MEMO

SUBJECT: Traffic Engineering Peer Review of iPark Expansion – Review of Applicant’s Revised Traffic Impact Study

DATE: May 27, 2021

Sign on Ingress from Main Ave (US Route 7)

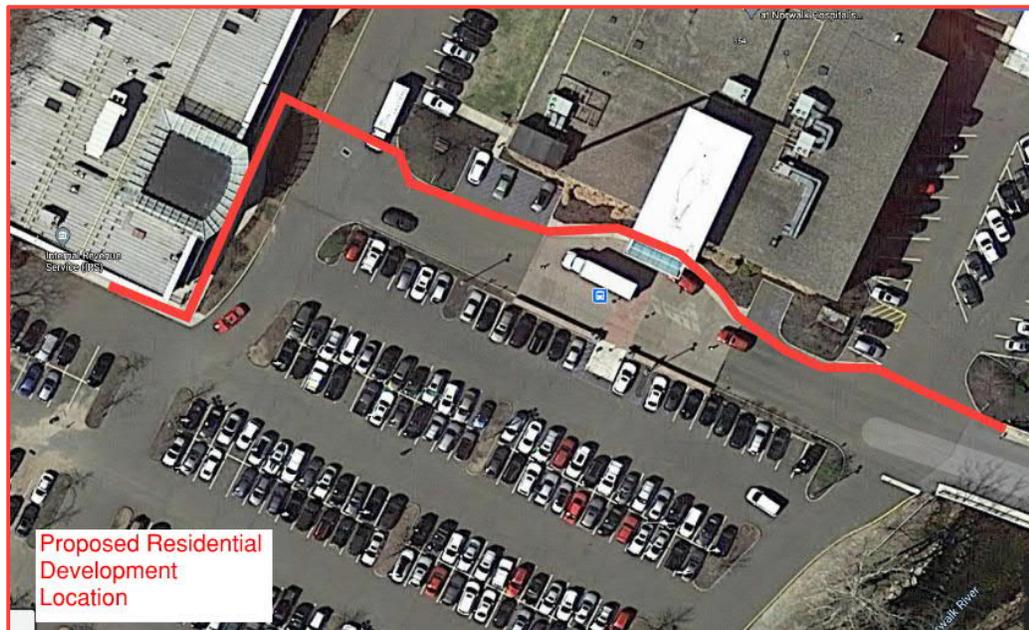
After the initial review, WSP noted that the provided plans do not address the pavement markings and signage needed to guide the potential residents and other site visitors in/out of the complex, regardless of travel mode. The sign shown in the following image, located at the ingress from the Main Avenue (US Route 7) and iPark Site Driveway/West Rocks Road intersection, guides drivers around the complex depending on where they are going. WSP recommended that an updated sign should be developed to include both the proposed residential development and the proposed hotel, in coordination with the other businesses/offices in the iPark complex. Additional recommendations regarding the incorporation of signage and pavement markings into conceptual plans is included in the Traffic Analysis section of this memorandum.

Recommended Pedestrian Path to/from Main Ave (US Route 7)

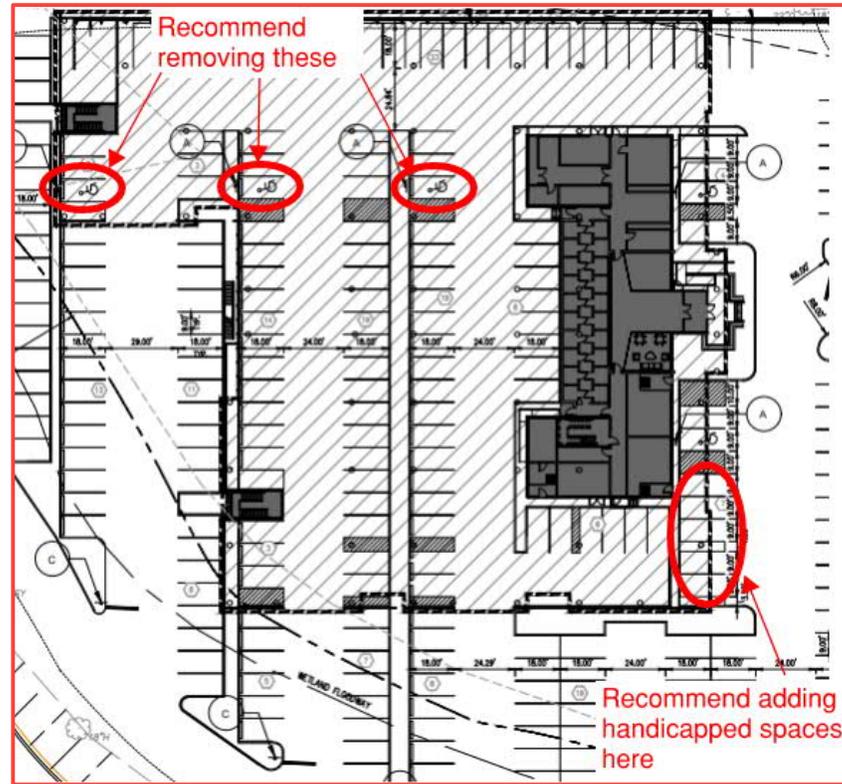
In the initial review, WSP commented that the Site Plan does not address pedestrian accessibility to/from the proposed residential development and Main Avenue (US Route 7). WSP recommended that marked crosswalks with ADA ramps be provided along the pedestrian path shown in the following image to connect to the existing sidewalks across from LA Fitness and the medical office building.
